Re: Initial Submission Review: 60th Avenue at Box Elder – Infrastructure Site Plan
Application Number: DA-1478-14
Case Numbers: 2024-6039-00

INITIAL SUBMISSION REVIEW

BOX ELDER SUBDIVISION FILING NO.2 INFRASTRUCTURE SITE PLAN

Job Number 24.0659
Project Manager PROULX
Design By BEDNAR/MEIS
Drawn By BEJARANO
Principal in Charge LE
Sheet Number: **2 OF 9**

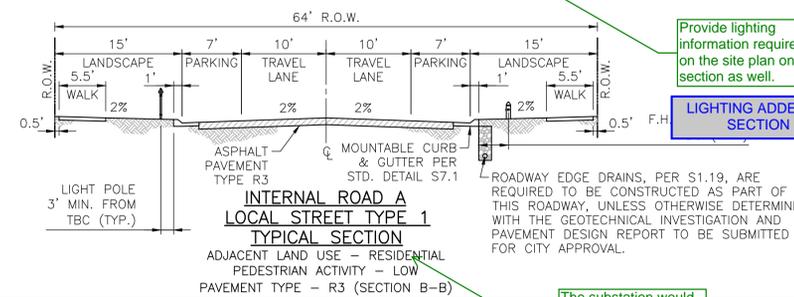
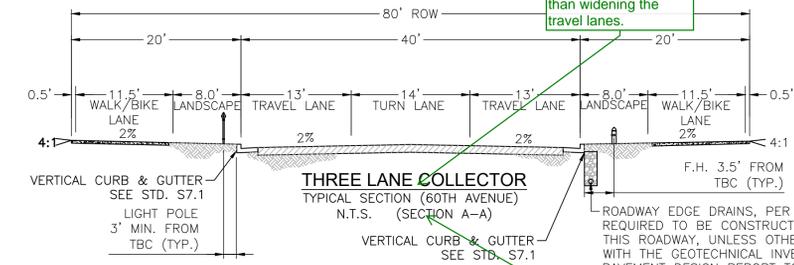
This statement is confusing. This site plan and the master plan establishes the required roadway section for 60th.

This section does not match the section from the master plan and does not match the section from the Roadway Manual. If the bike lanes are removed from the section, the sidewalks shall be widened to a minimum of 13' rather than widening the travel lanes.

Provide lighting information required on the site plan on this section as well.

The substation would be considered more industrial. Revise the pedestrian activity level to medium.

REMOVED THIS NOTE AS THERE ARE NO PLANS FOR THE ROADWAYS TO BE PHASED

STREET SECTION UPDATED TO MATCH FULENWIEN MASTER PLAN

LIGHTING ADDED TO SECTION

Job Number 24.0659
 Project Manager PROULX
 Design By BEDNAR/MEIS
 Drawn By BEJARANO
 Principal in Charge LE
 SHEET 3 OF 3
 SHEET NUMBER: 3

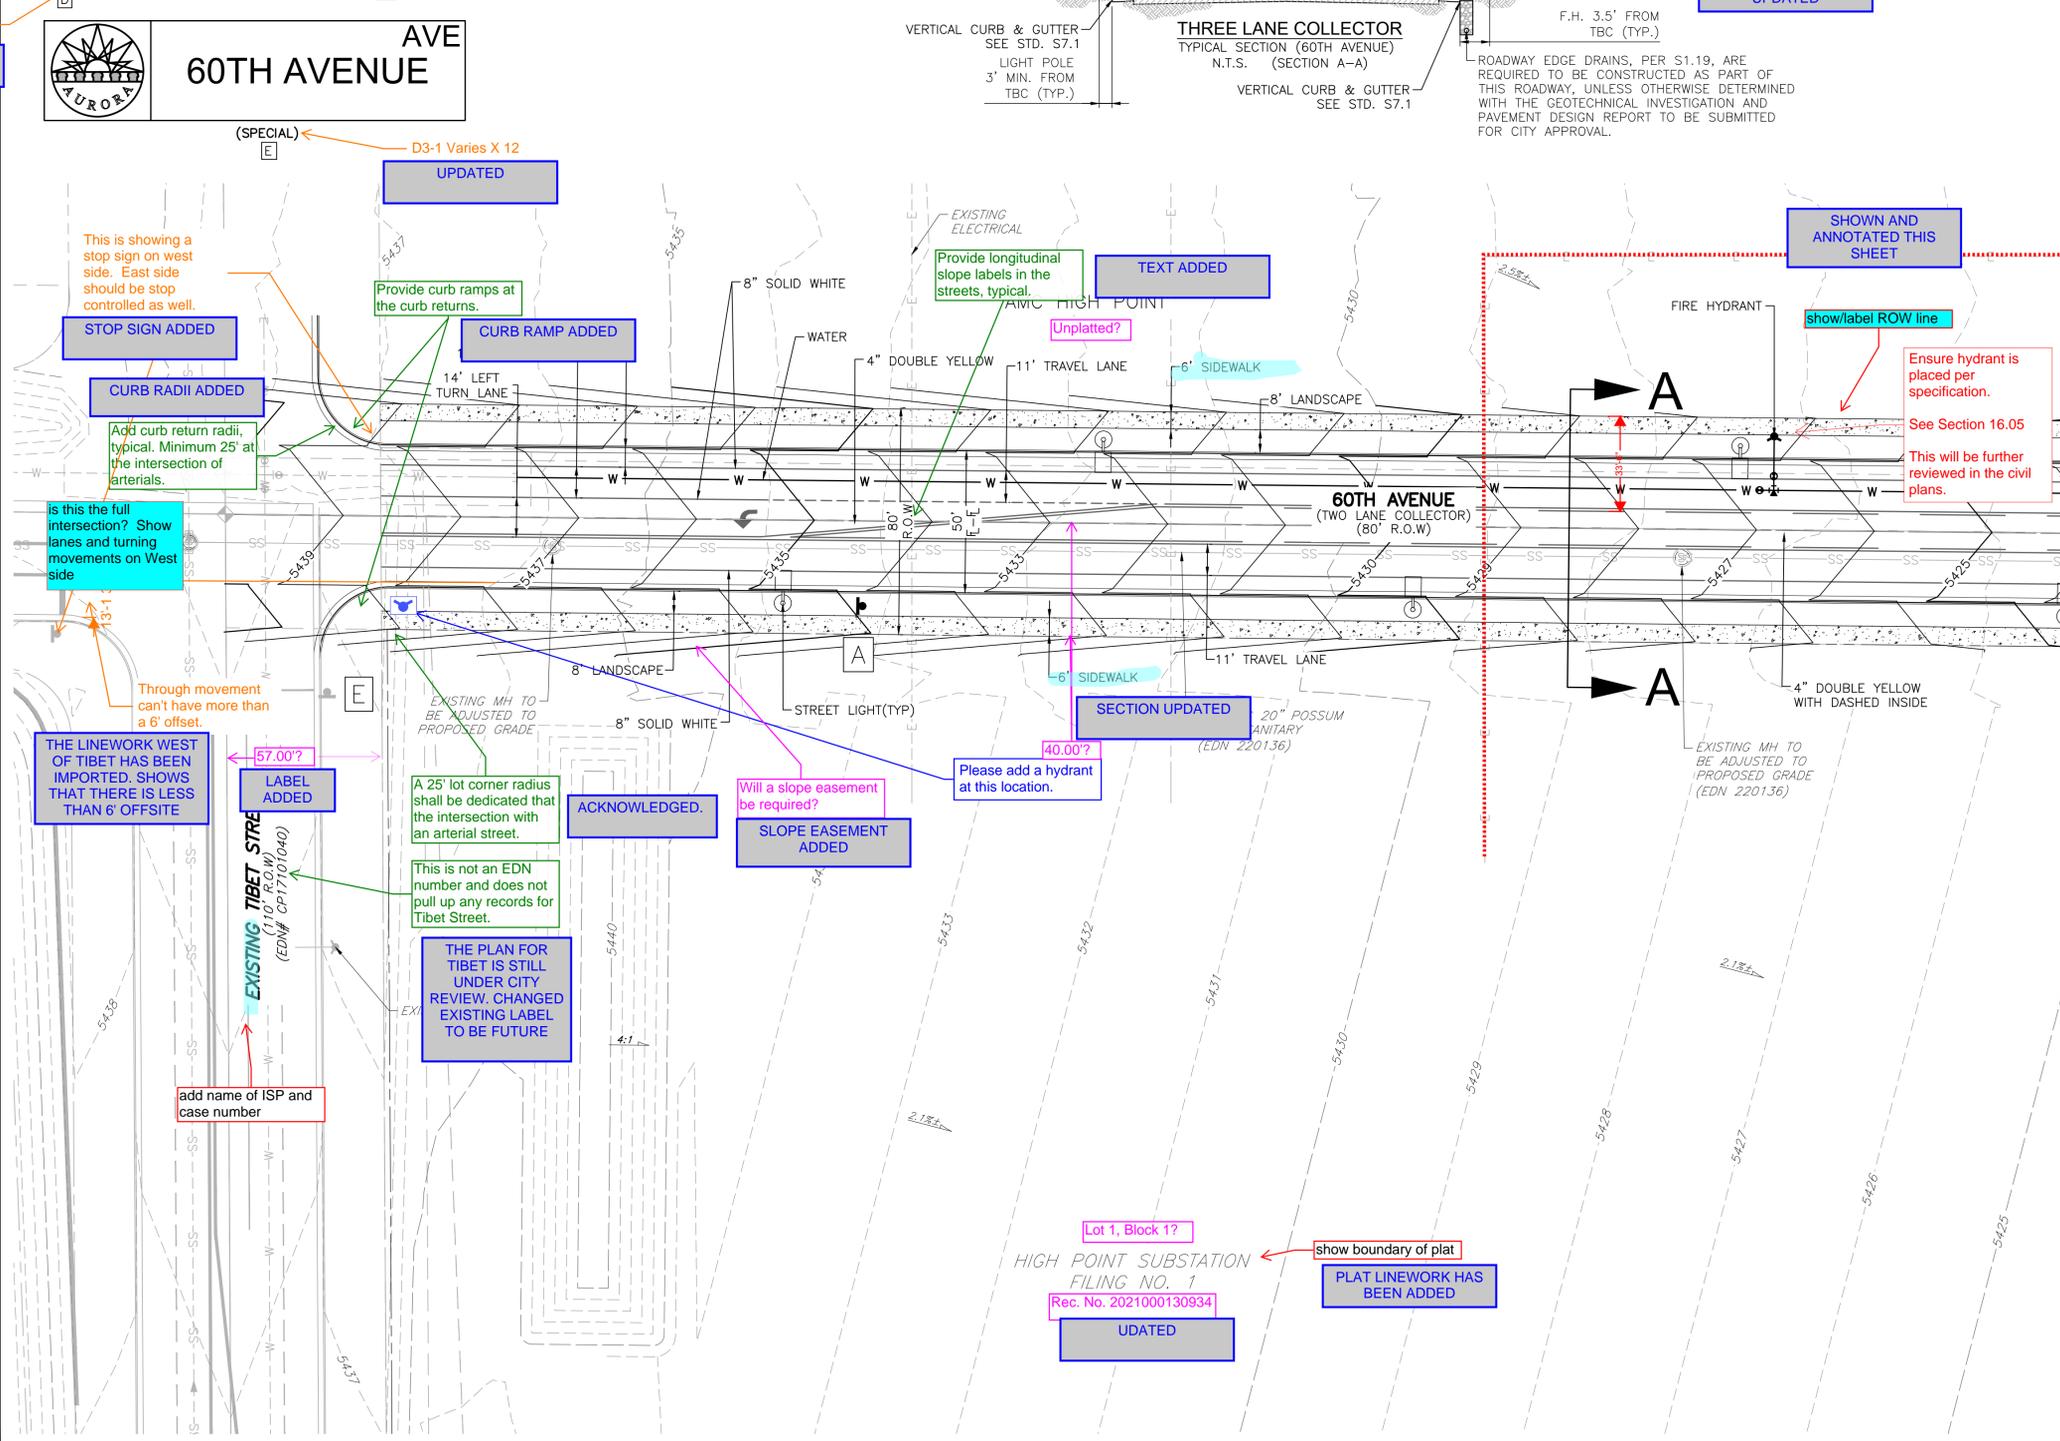
- ELEVATION = 5394.58' (NAVD1988) DATUM.
- Please add the following note: "The maximum slope within ROW is 4:1, the maximum slope for property outside of the ROW is 3:1."
 - Please add the following note: "The maximum cross slope in an accessible path shall not exceed two percent. The maximum longitudinal slope in an accessible path shall not exceed five percent."
 - Please add the following note: "Detailed layout and design for proposed curb ramps within right of way or along an accessible route will be completed with the civil plans."
 - Please add the following note: "The minimum slope on asphalt is 1%, the minimum slope concrete is 0.5%, and the minimum slope on unpaved surfaces is 2%."

Sheet Number:
WEASEL DRAINAGE

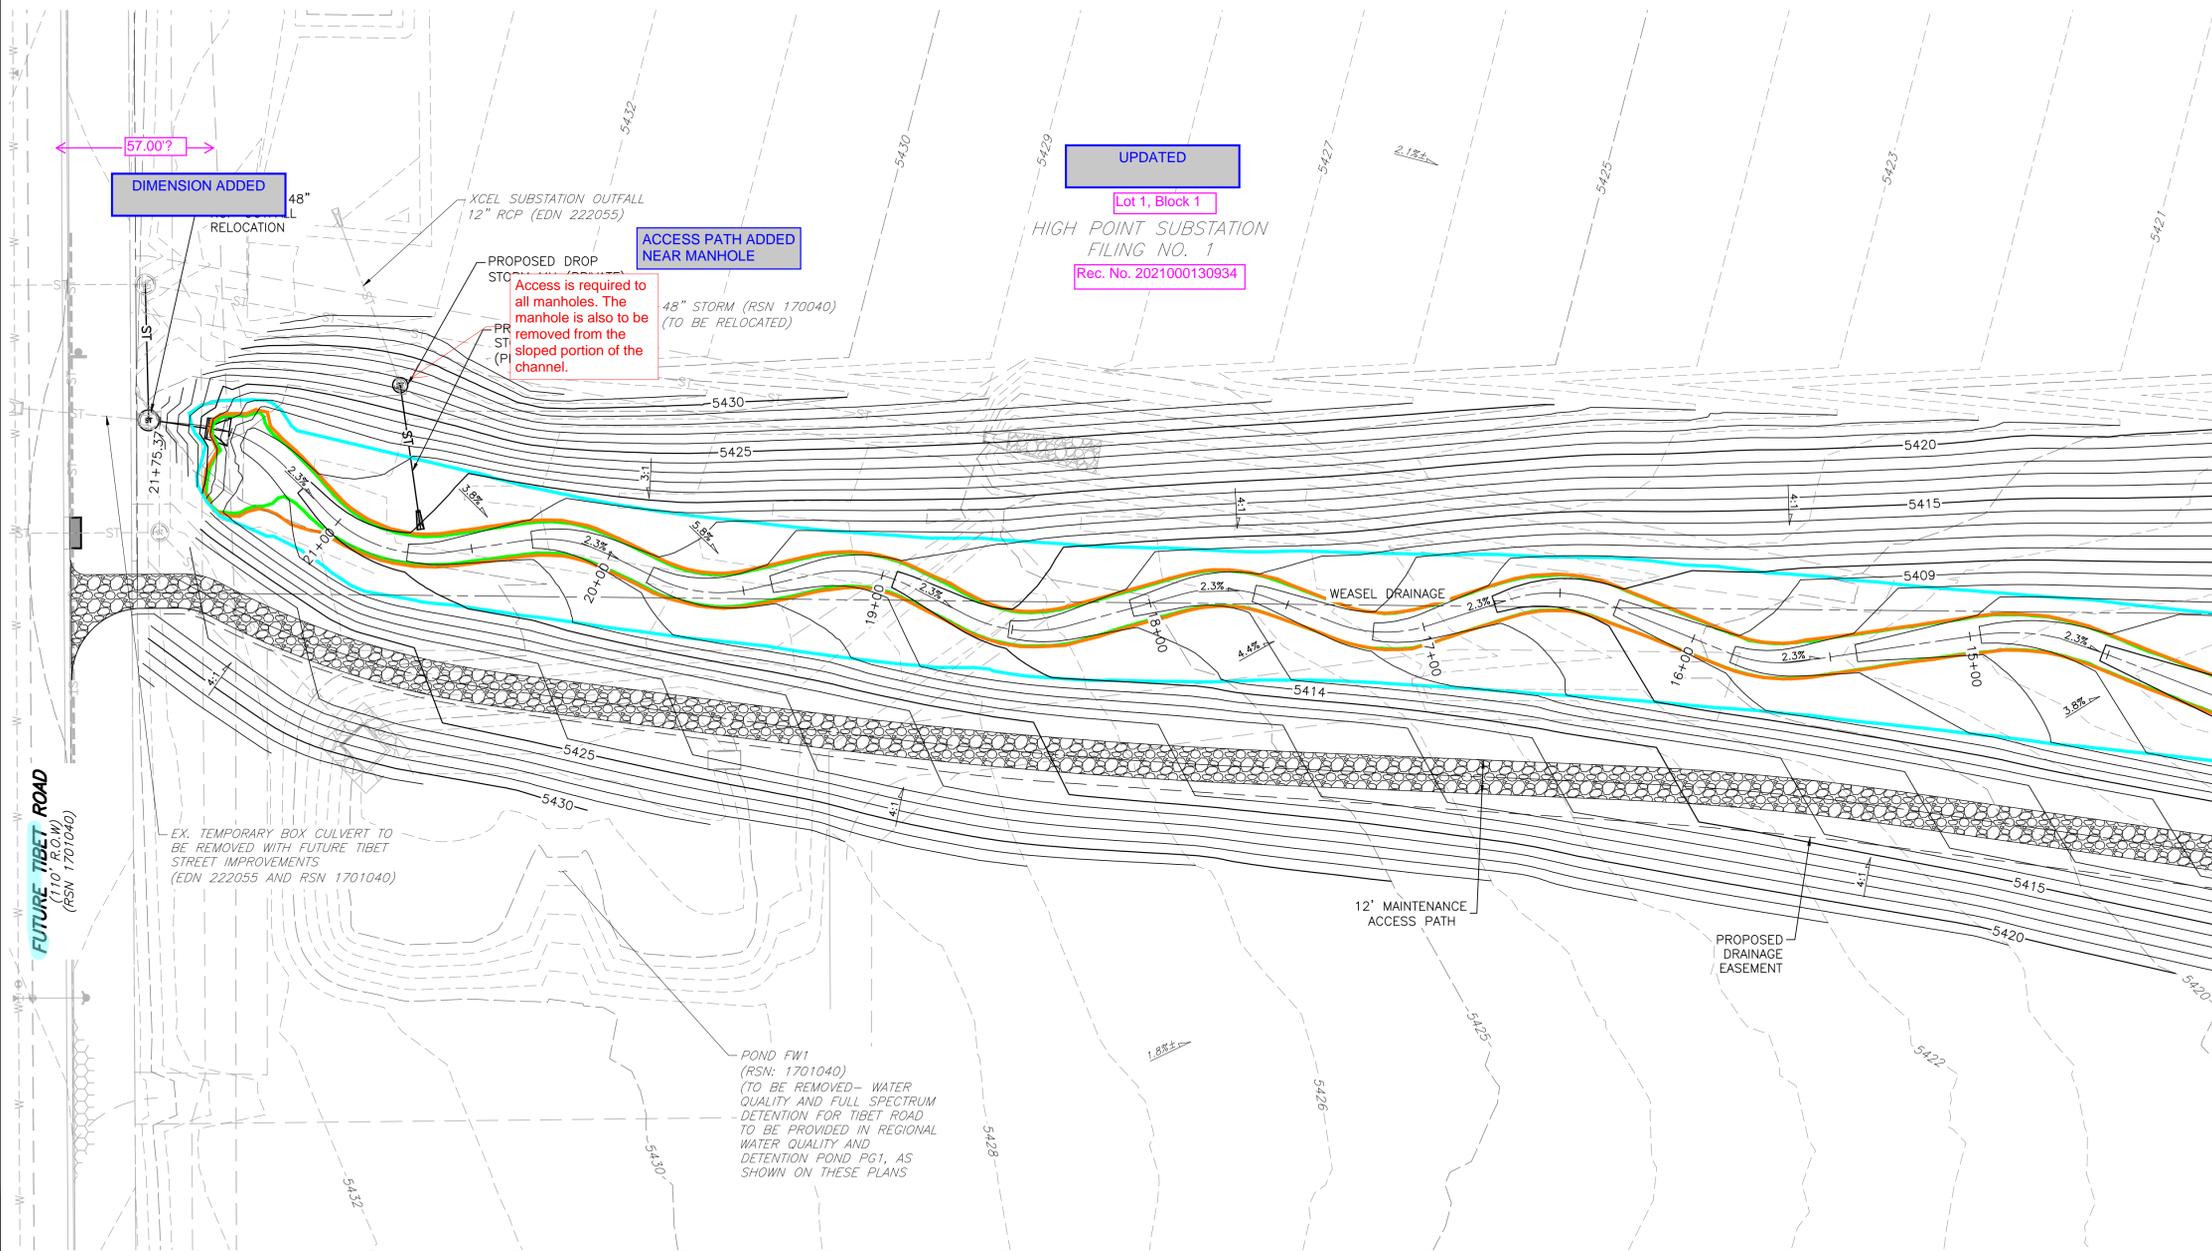
Add sheet number.

ADDED

DIMENSION ADDED
57.00'

ACCESS PATH ADDED
NEAR MANHOLE

1 TYPICAL BUFFER SECTION

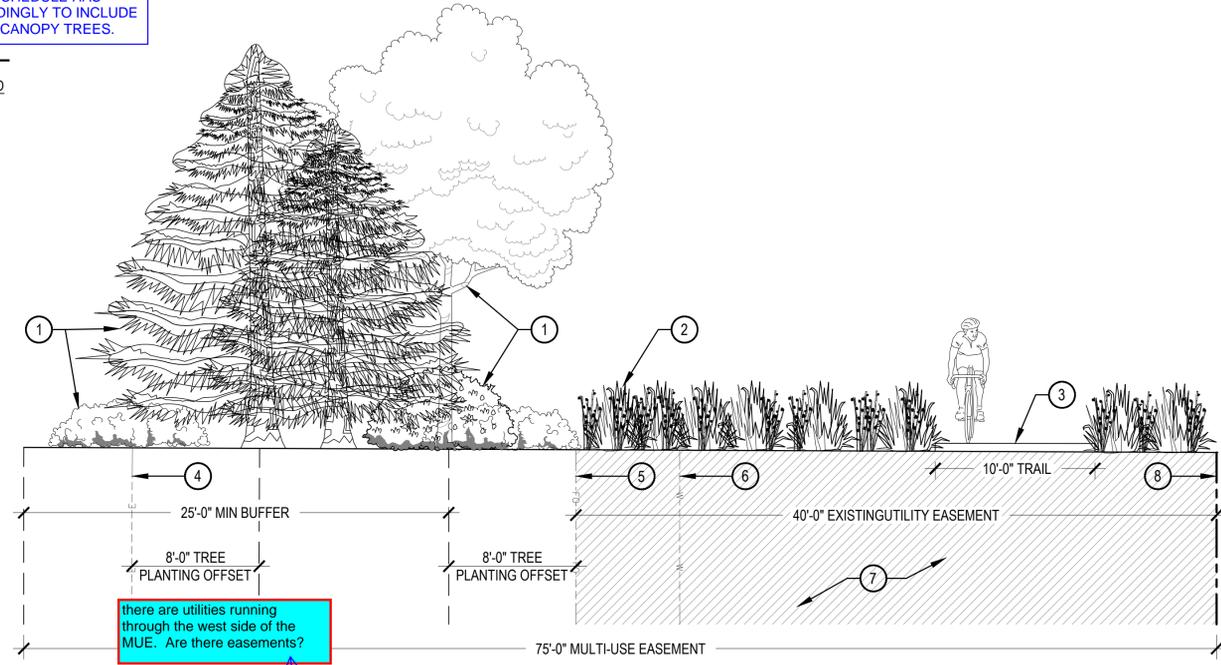
Per sheet 10 under each landscape requirement table there is a note that all trees shall be 2.5" caliper, but none are specified on the plant list.

ND RESPONSE: PLANT SCHEDULE HAS BEEN UPDATED ACCORDINGLY TO INCLUDE 2.5" CALIPER SPEC FOR CANOPY TREES.

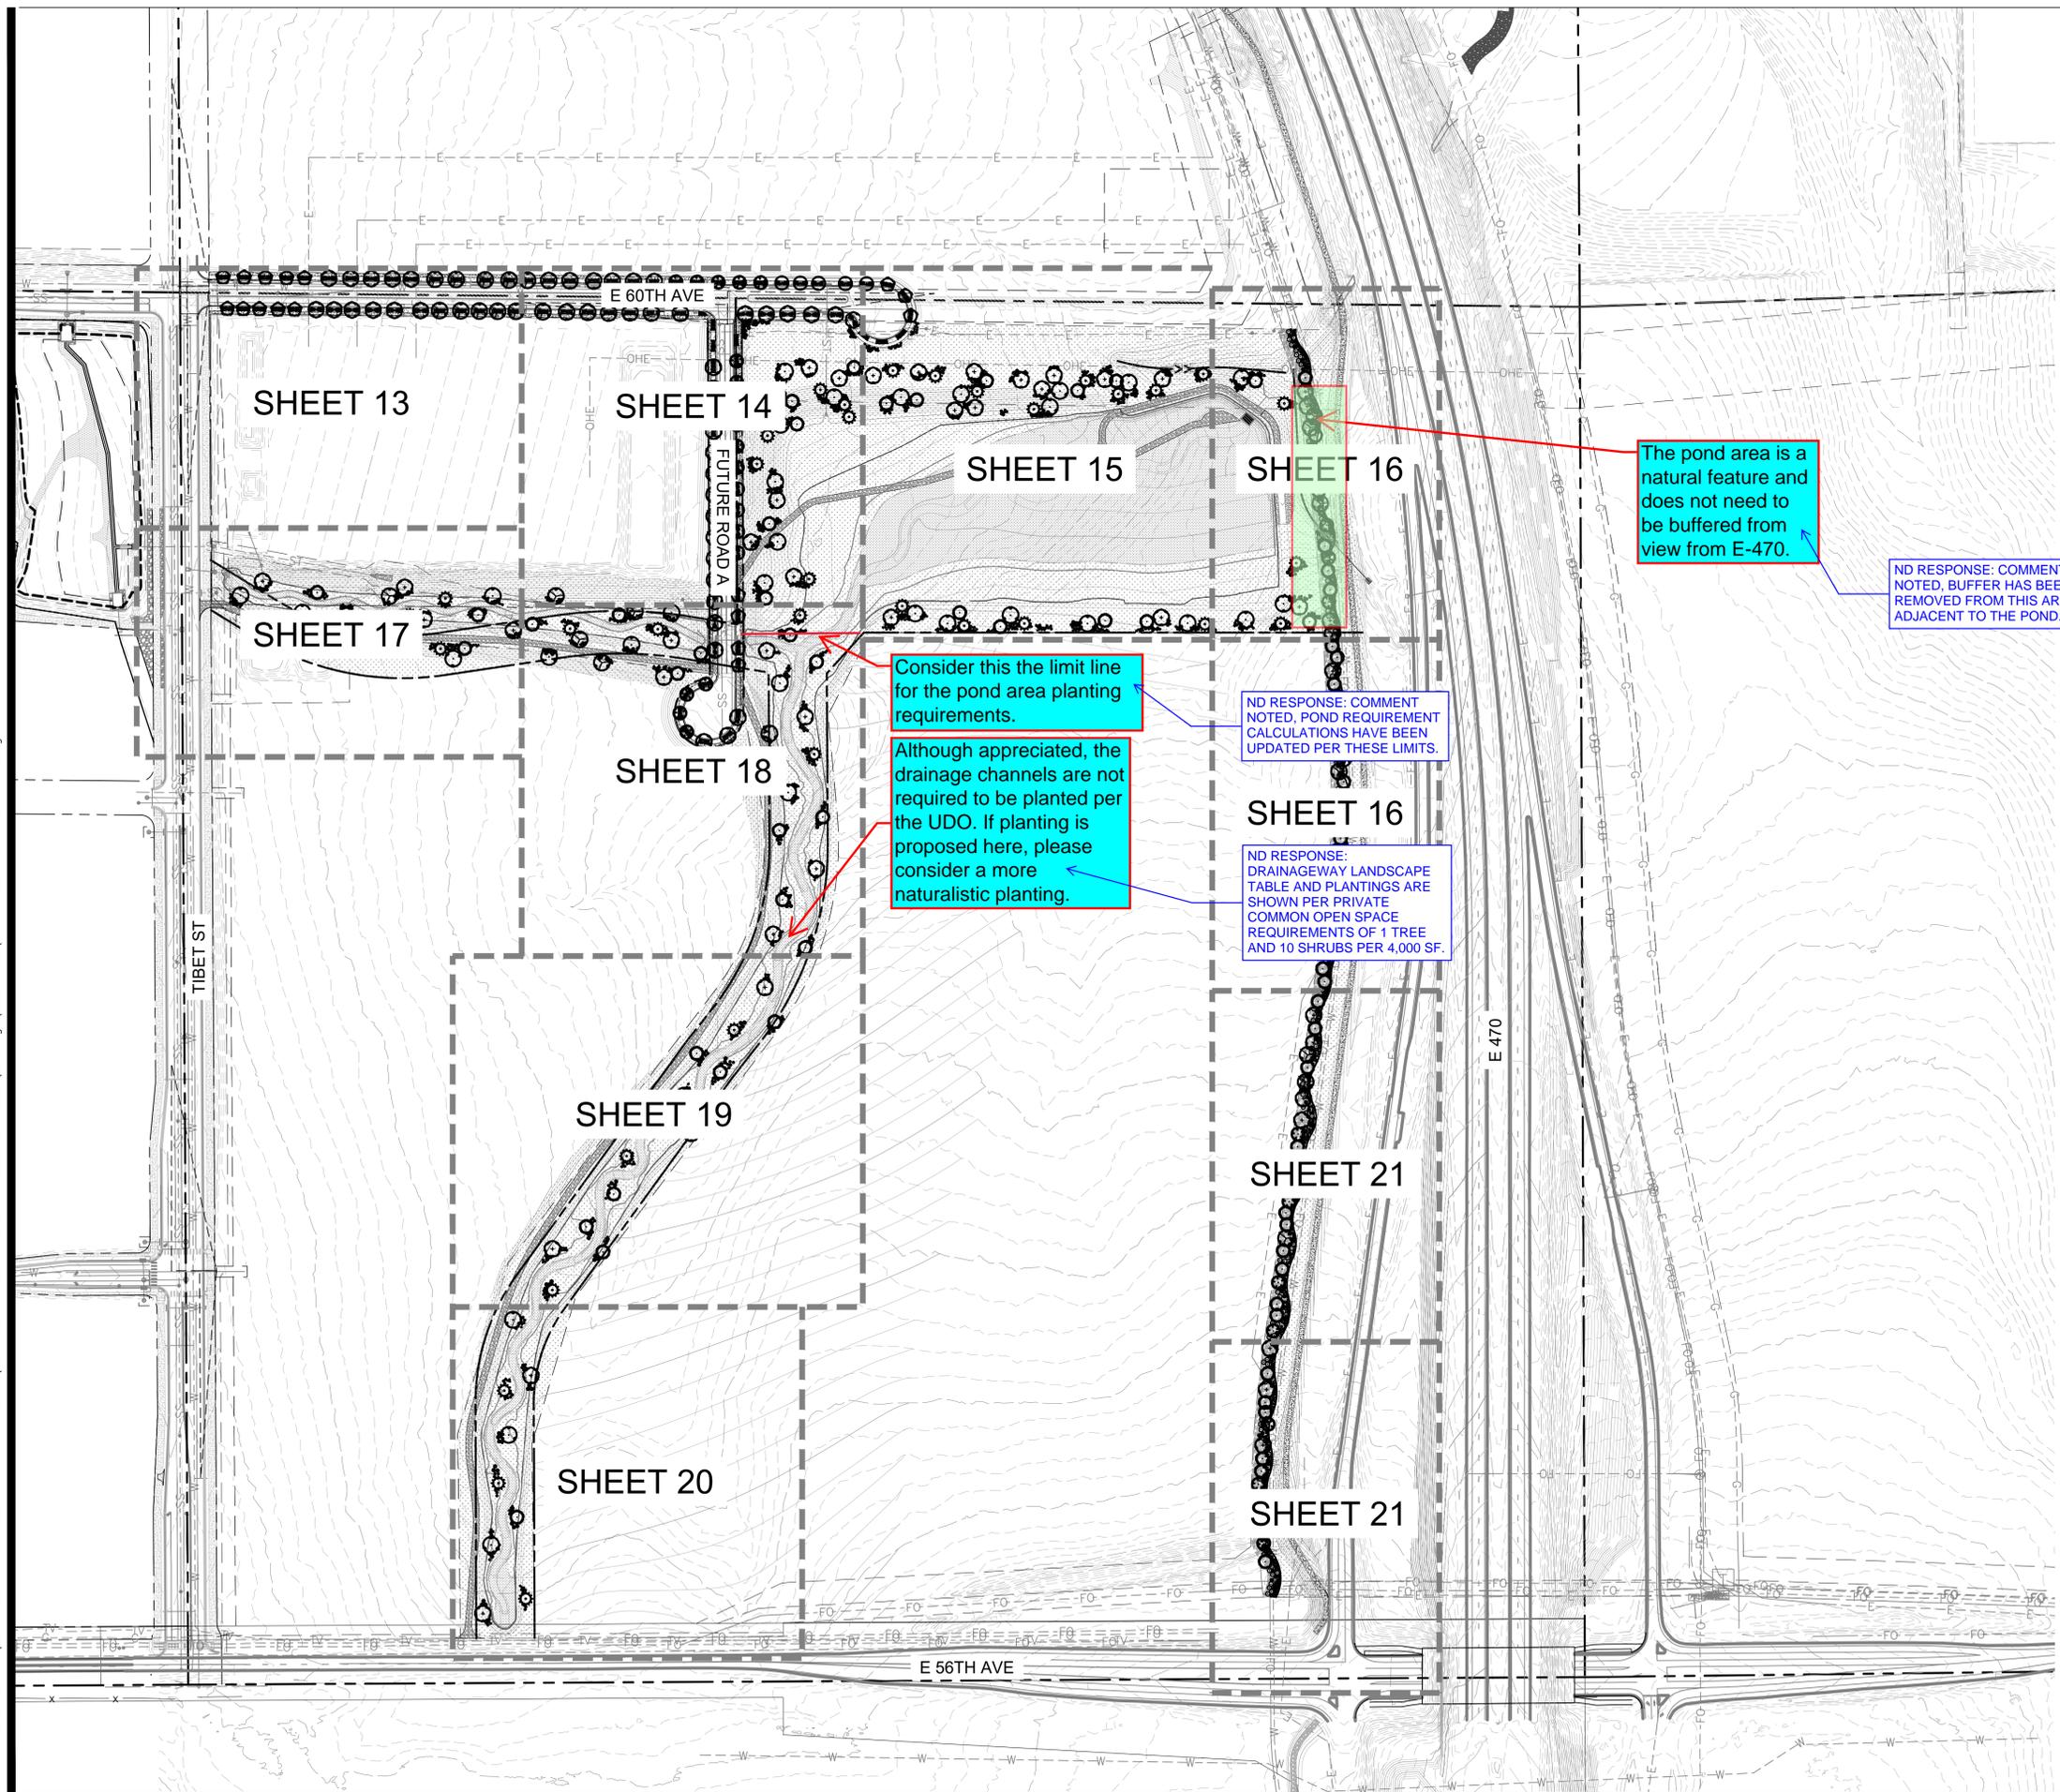
The pond area is a natural feature and does not need to be buffered from view from E-470.
